Minor Change to Development Approval at 281-297 Montague Road, West End QLD 4101 (Council Ref.: A006885806)

This Minor Change application captures a discrete suite of refinements to Stage 1 of the approved development, which have arisen through further design development and construction efficiency review. The proposed changes are directed toward enabling the efficient and timely delivery of Stage 1, while maintaining the overall intent, form and function of the approved development.

Figure 8 – Overall Ground Plane

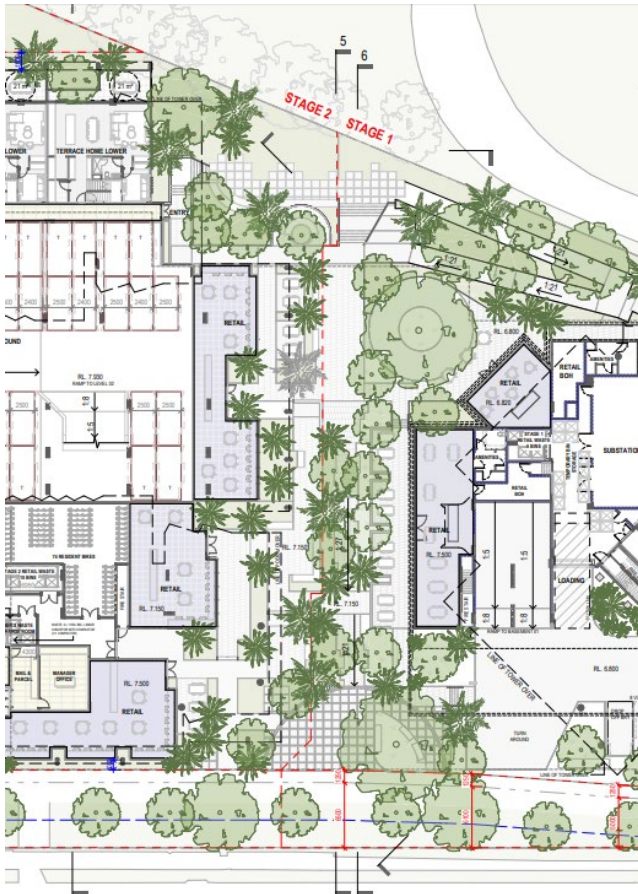
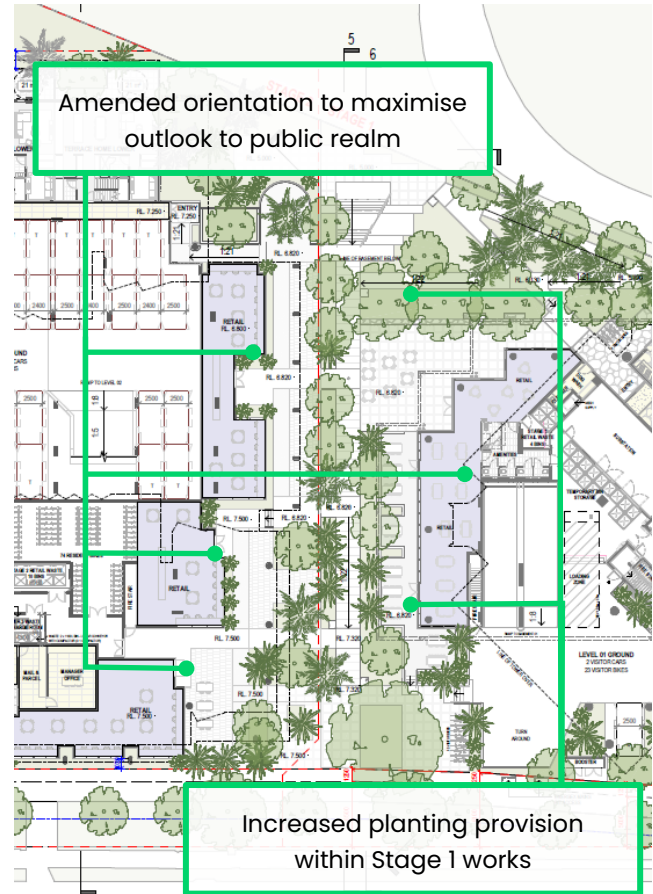
- **Maximising connectivity and landscape character** – the retail tenancies, outdoor activation areas and associated amenities forming the approved ground plane are reconfigured to further orient active uses and vibrancy towards Davies Lane and the civic area which interfaces with Davies Park (see **Figure 8**).

To further offer a pocket of respite and soften the urban streetscape, increased planting is incorporated within Stage 1 works, ensuring the proposed tree-lined promenade sleeved by retail and immersed in subtropical planning, delivers permeability through the site while extending the life and energy of the high street into the precinct.

Figure 10 – Vehicular access arrangement (Stage 1)

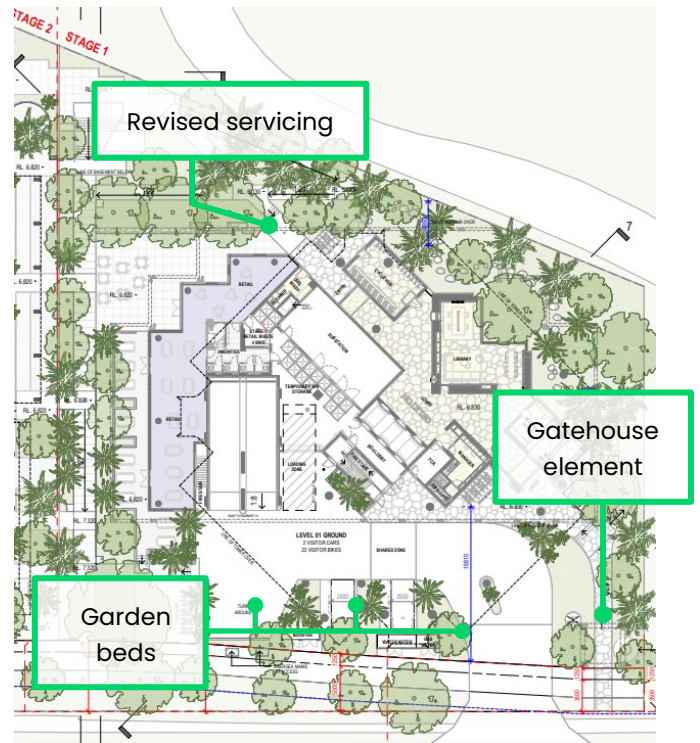
- **Improving access arrangements and security** – increased landscaping, including garden spaces are proposed at the vehicular access points via Montague Road, improving legibility and establishing a clear identity for the development within the streetscape (see **Figure 10**). A gatehouse element has been added for Stage 1, providing a welcoming entrance that connects the street to the lobby of Stage 1.

Figure 12 – Typical Floorplate

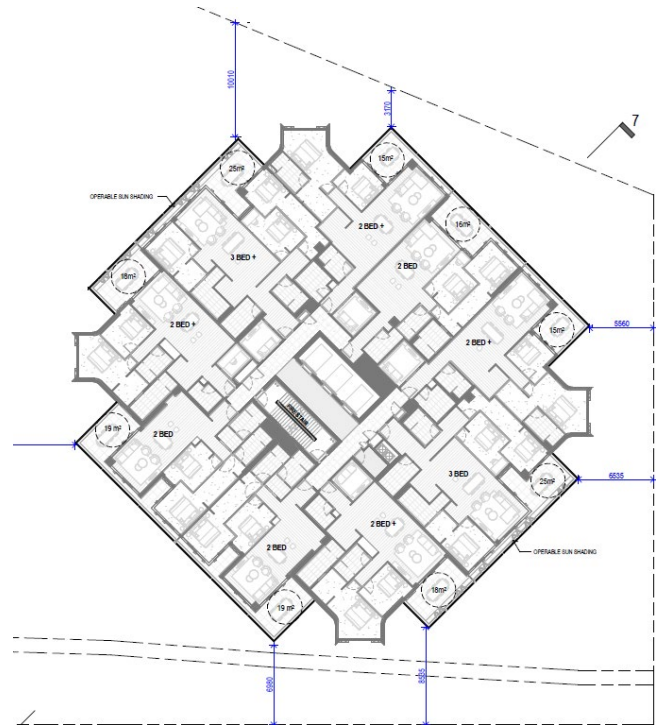
- **Refining internal layouts:** As a result of the detailed design process, minor amendments are proposed to the internal unit layouts of typical floorplates within the towers, as shown in **Figure 12** below (refer to **Appendix D – Revised Plans of Development**).

Figure 13 – Rooftop Plan

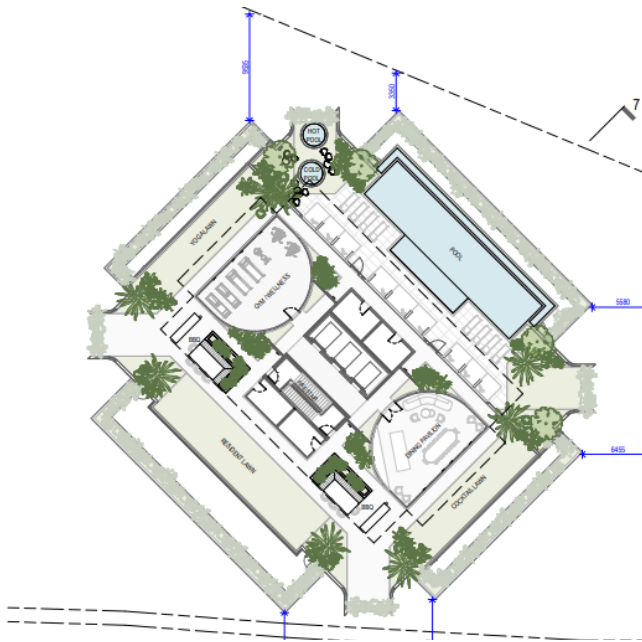
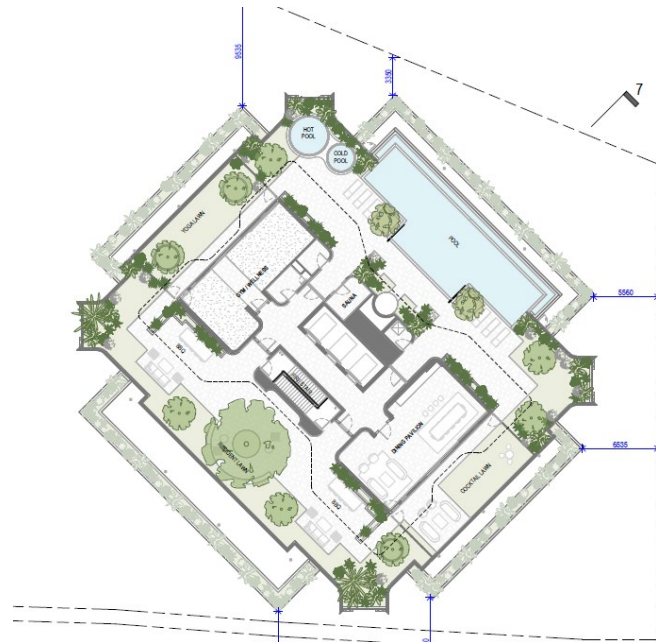
- Redesigning rooftop facilities:** Additional consideration has been given to further develop the rooftop recreation spaces, ensuring the intent to deliver a “piece of the park” into the skyline is delivered. The landscape character established by the development is extended vertically, maintaining a landmark presence within the precinct through increased rooftop landscaping, including provision of additional open lawn areas and substantial tree planting. **Figure 13** below provides a comparison of the approved and proposed rooftop design (refer to **Appendix D – Revised Plans of Development**).

Figure 15 – Staging Boundary

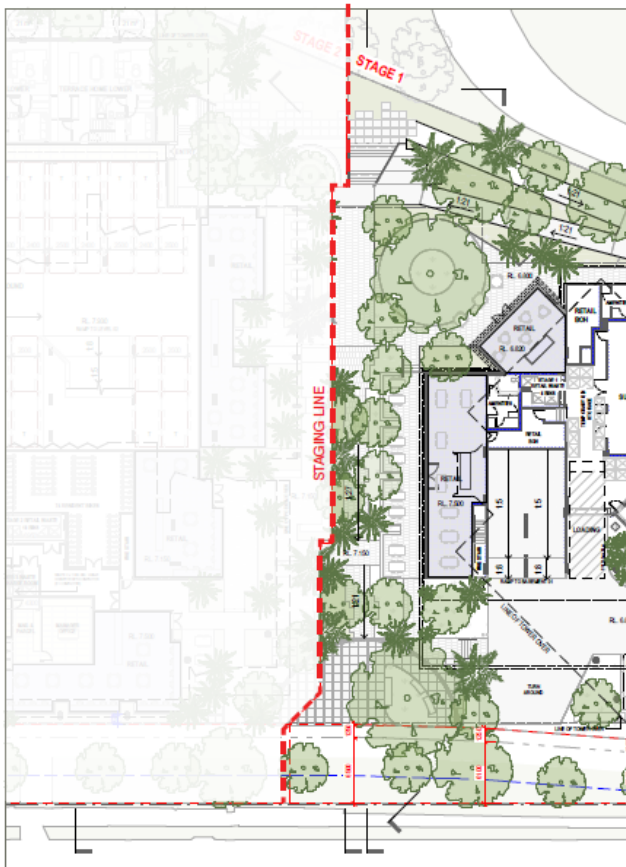
The development continues to be delivered in two stages, as illustrated in **Figure 15** below. The proposed changes in this regard include the realignment of the staging boundary line, to create a more linear, clearly discernible and orderly boundary than the arrangement previously approved. This change further ensures additional landscape provision is delivered within Stage 1 works.

- **Stage 1:** Comprised of Tower 1 with 157 residential apartments and rooftop residential amenities, including a gym, pool, dining pavilion, yoga space, cocktail terrace and resident lawns. This stage also delivers the full basement car parking, establishing the base for the wider development. It will deliver significant public realm improvements, deep planting zones, and pedestrian connections through to Davies Park, enabling early activation of the site and an immediate community interface.
- **Stage 2:** Comprised of Tower 2 and 3, delivering 248 residences alongside podium-top resident facilities. Tower 2 also maintains a rooftop communal area featuring barbeque areas, a dining pavilion, and lawns.

The proposed staging is responsive to the construction requirements of the development. Scaffolding and hoarding zones for Stage 2 of the development have been incorporated into the staging line to ensure that construction for Stage 2 can be executed in a safe, efficient and timely manner. During construction of Stage 2, a very small portion of Davies Land and the verge will be temporarily closed to provide for a construction
